ROLLIN RIDGE Filing No. 1 Grading & Erosion Control Plans El Paso County, Colorado

Remove Filing 1 and replace with
Pre-Development Grading & Erosion Control
Plans.

ROLLIN RIDGE ESTATES - FILING NO. 1

**GEC PLAN
TITLE SHEET**

* PERFORATIONS AT 4" VERTICAL SPACING

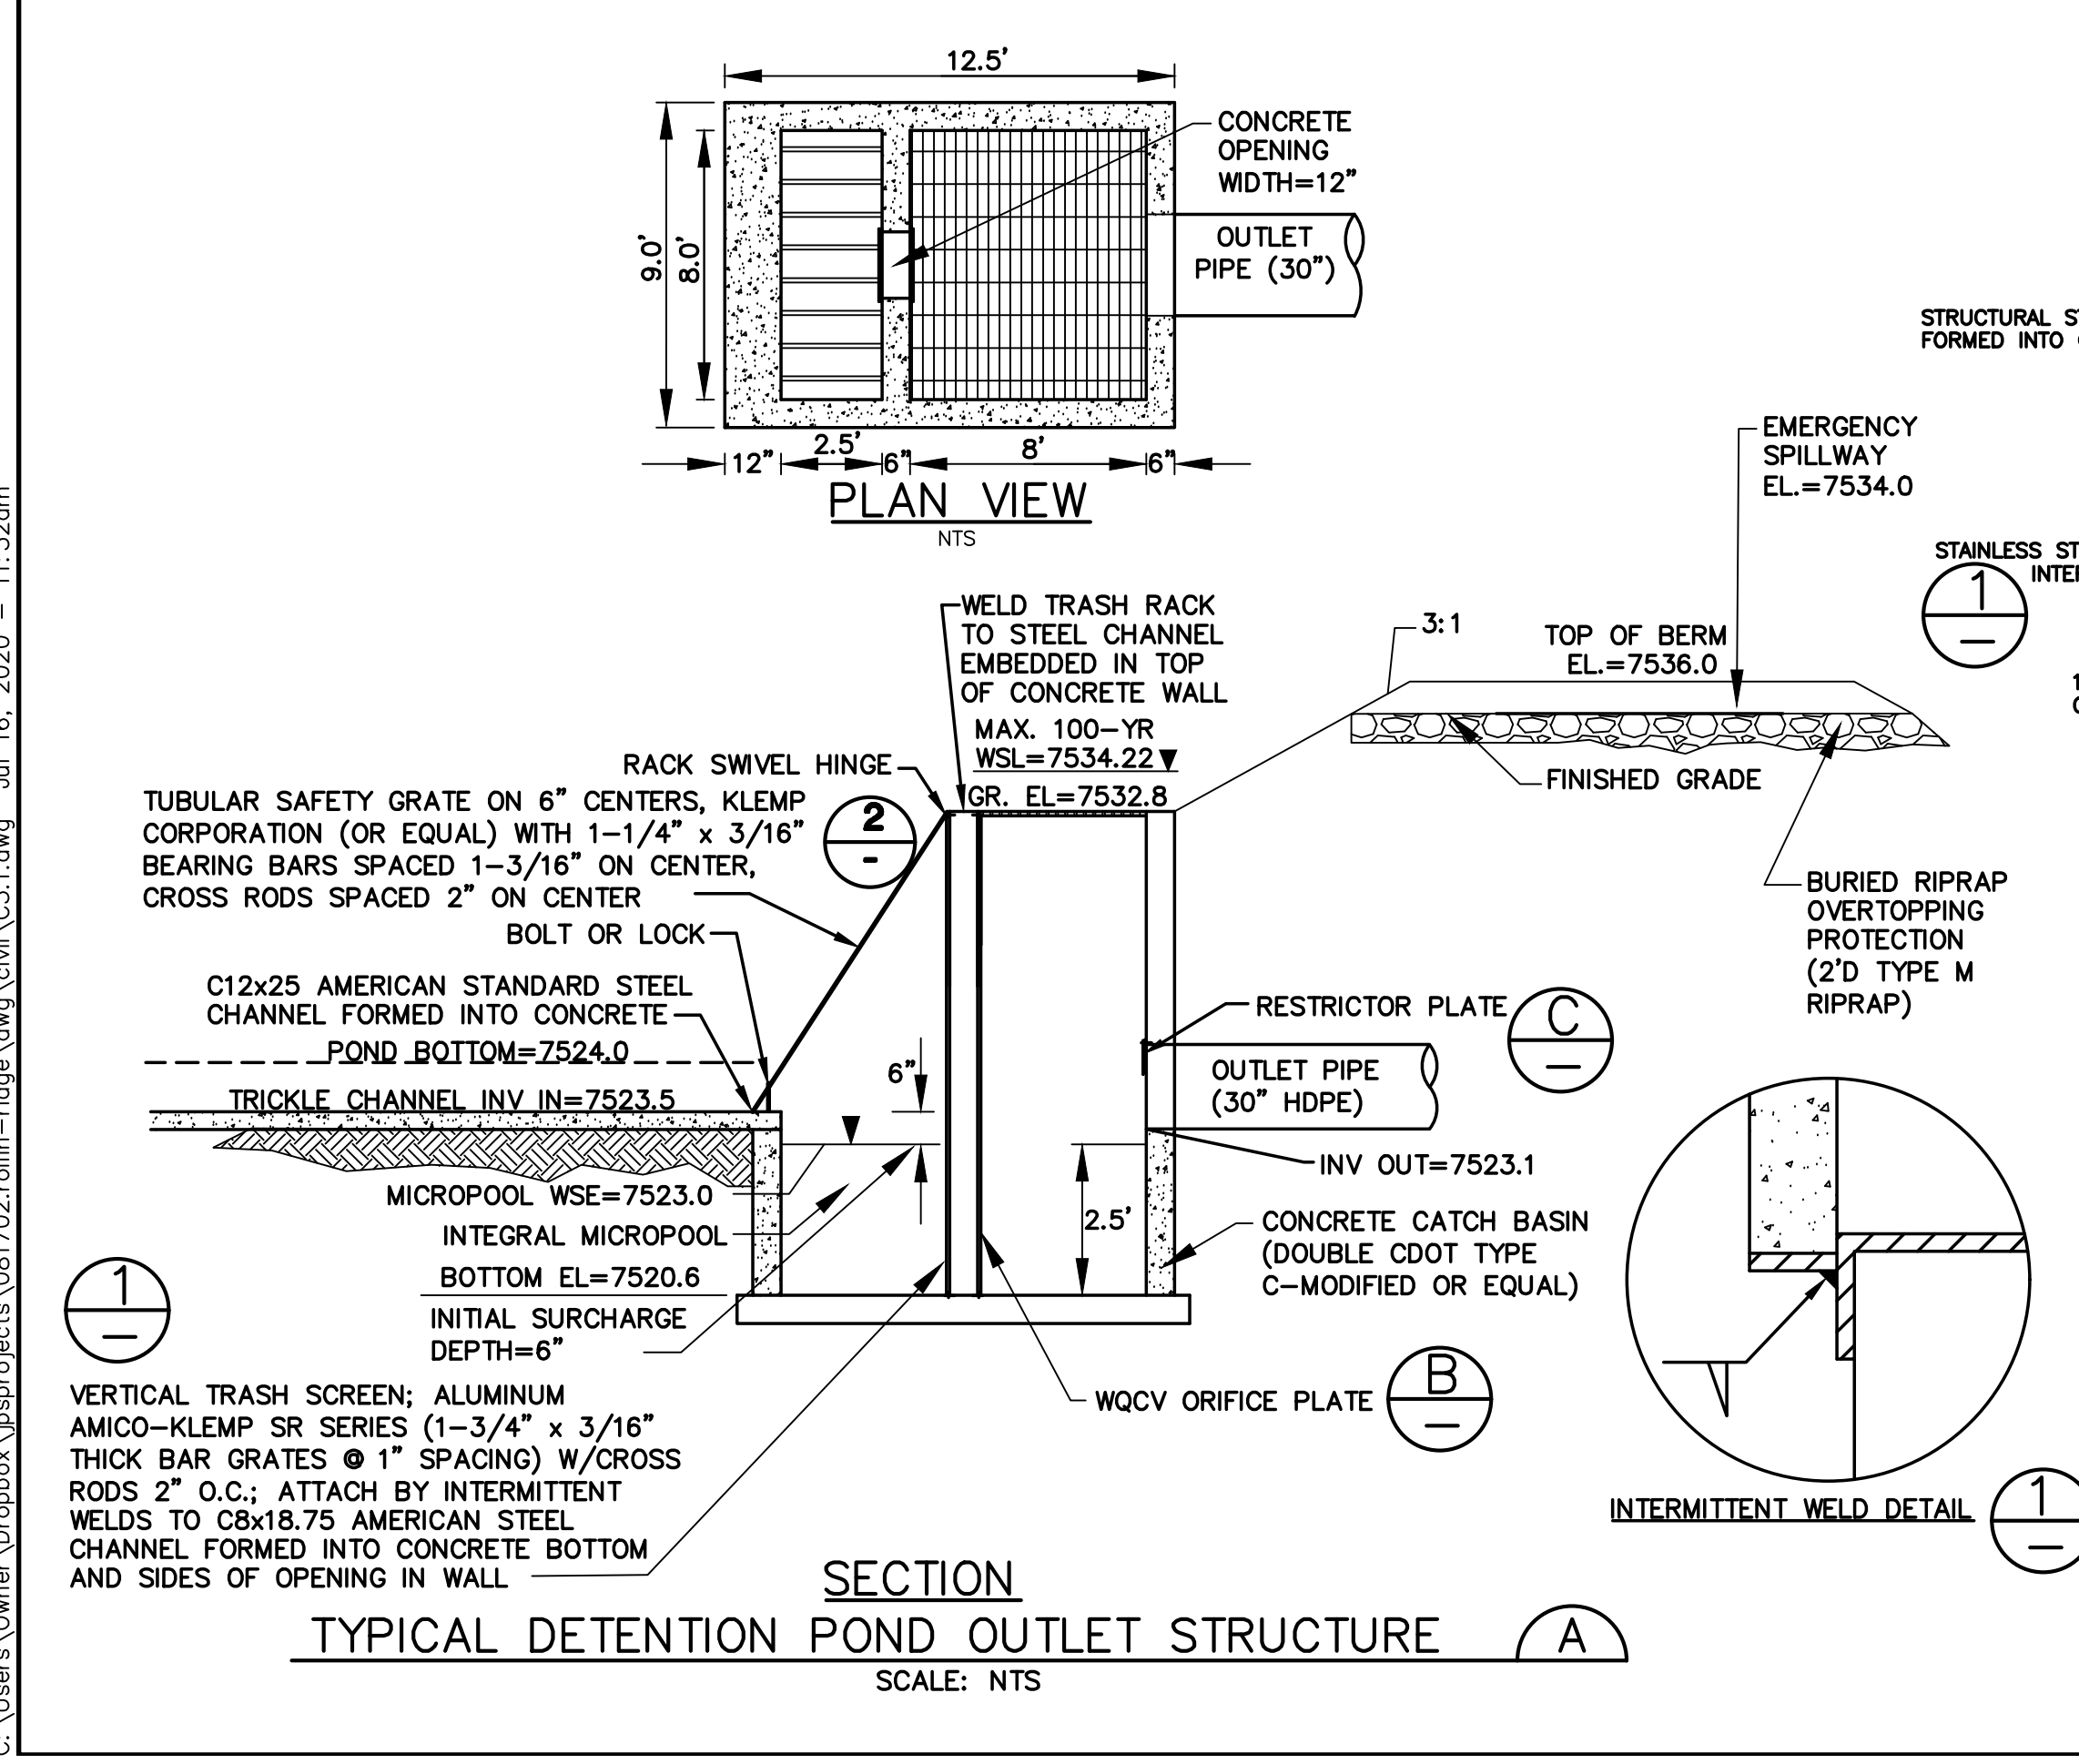
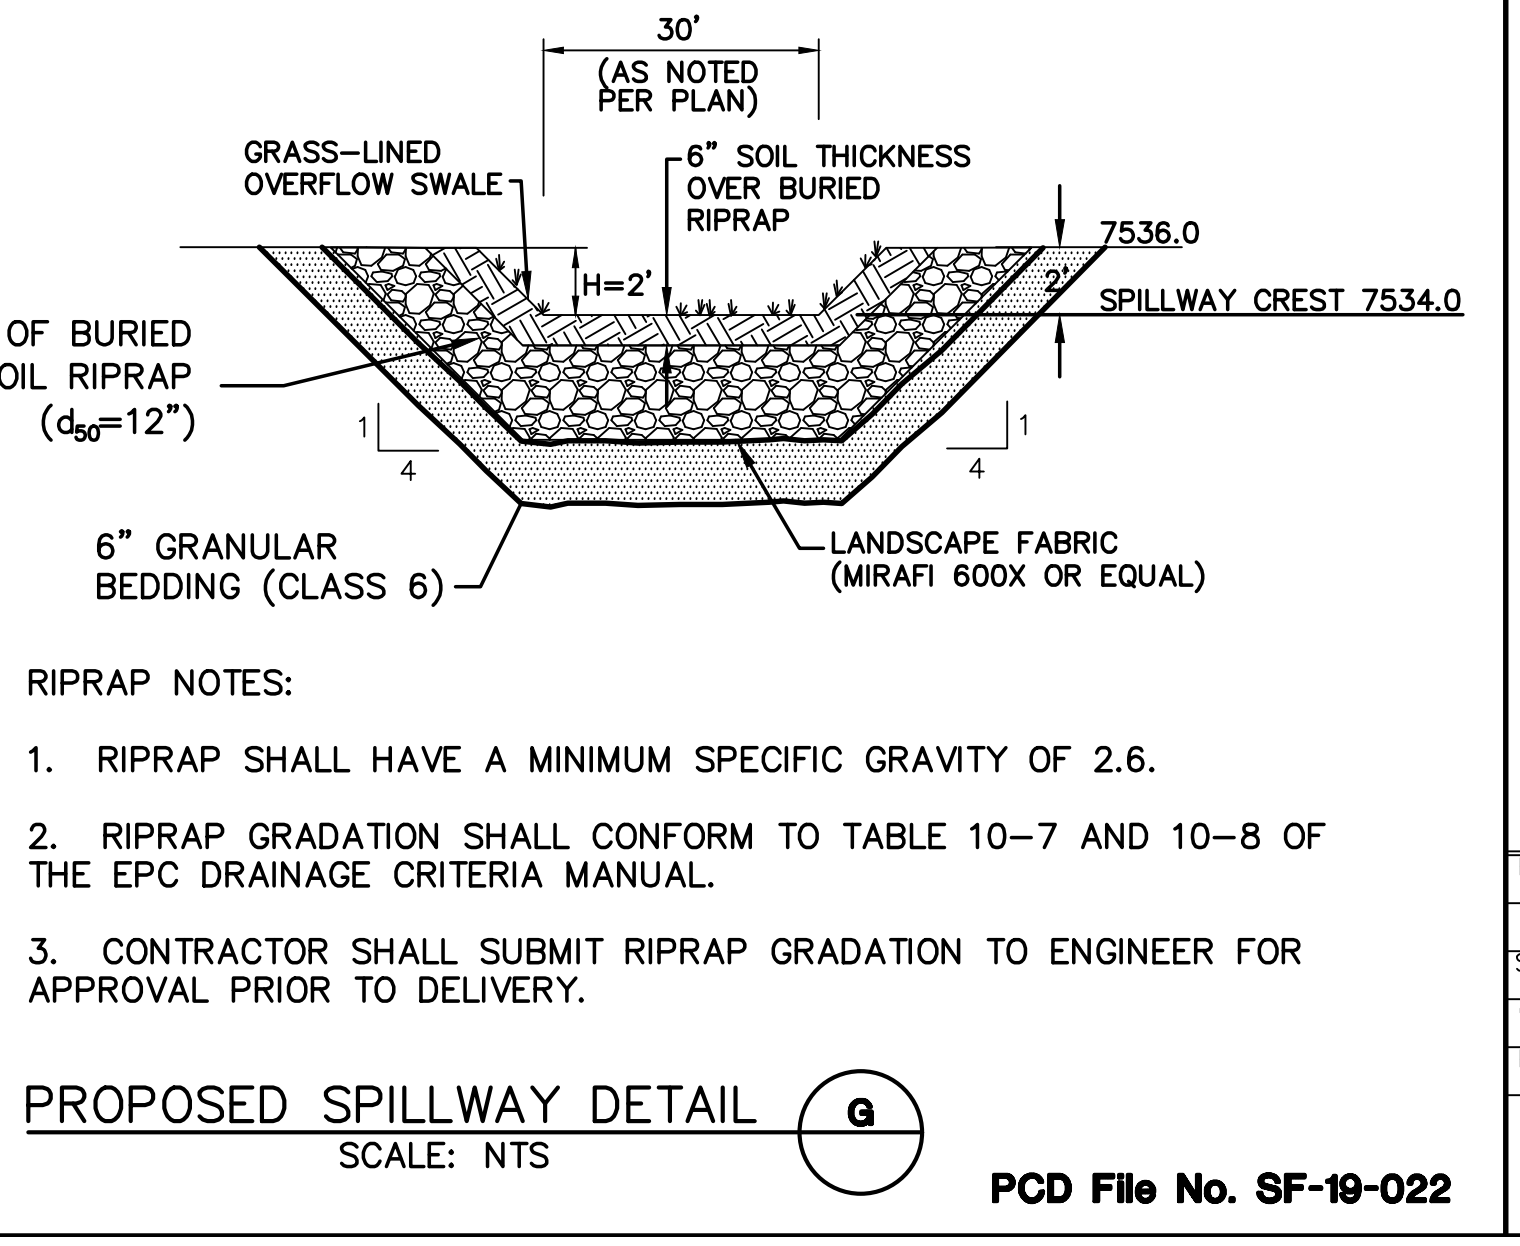
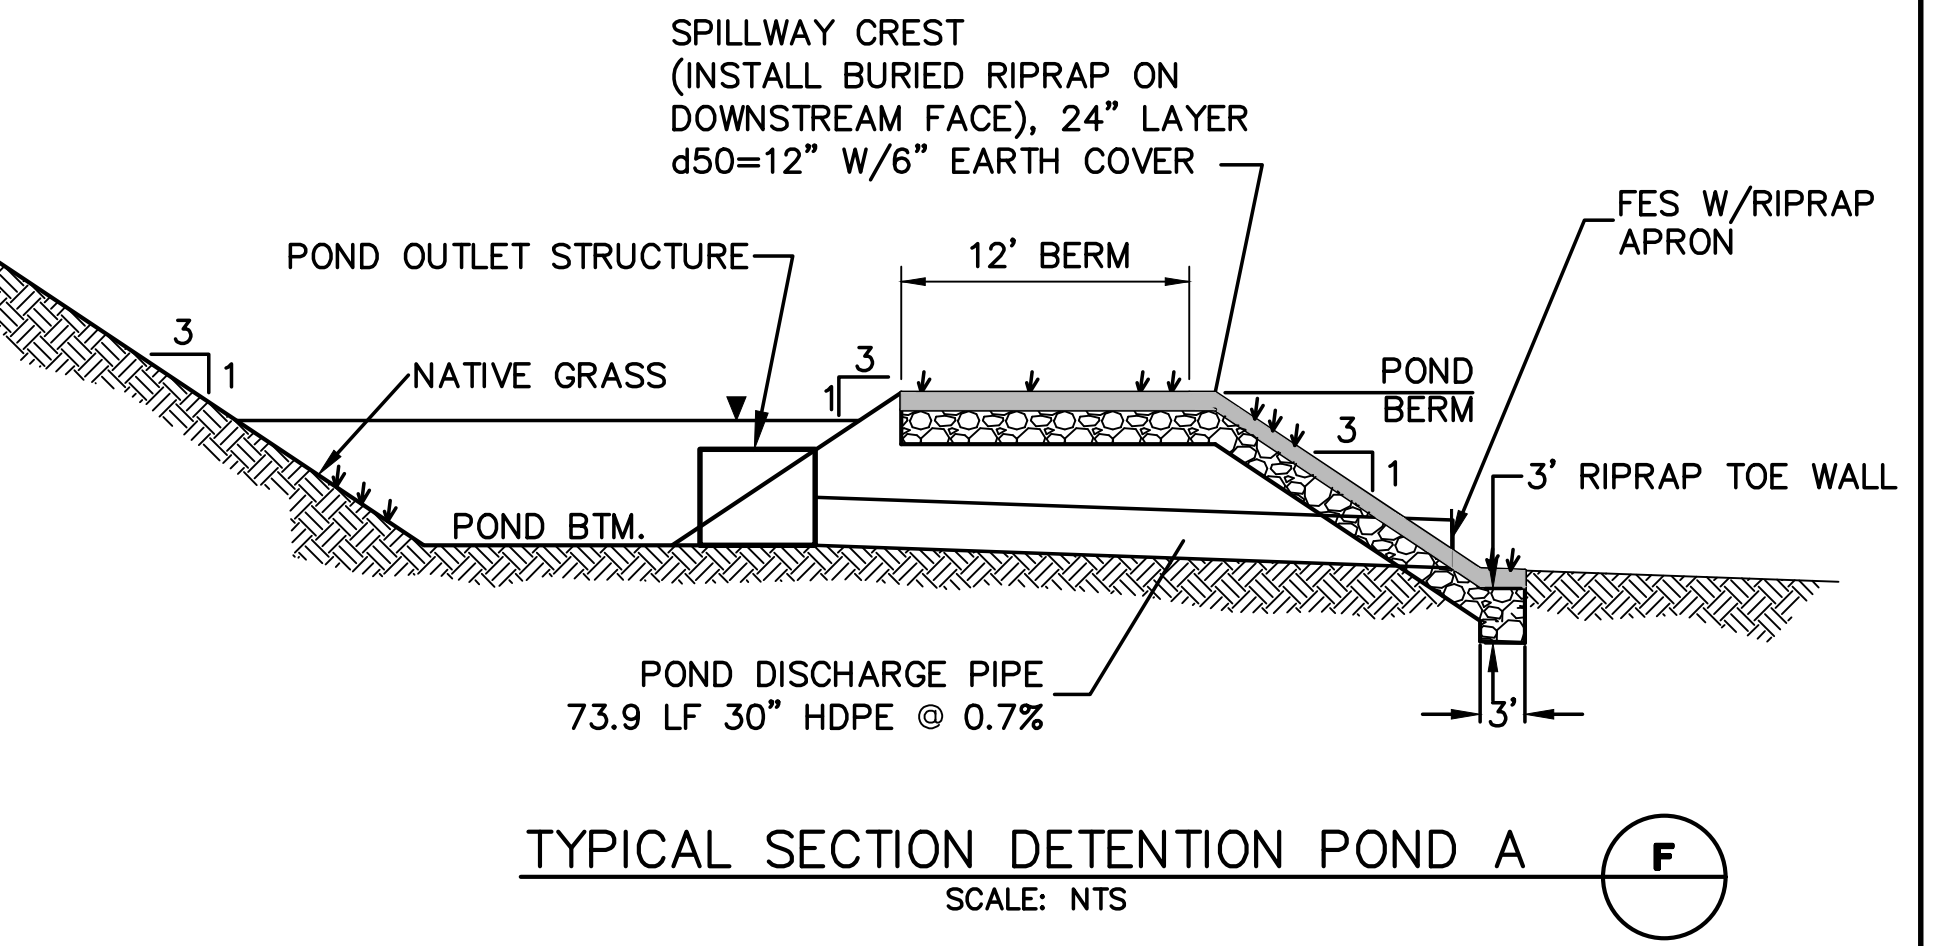
Keep this table for each TSB in plans for EGP

Remove permanent pond outlet structure details. These are approved with the Filing 1 application not the early grading application.
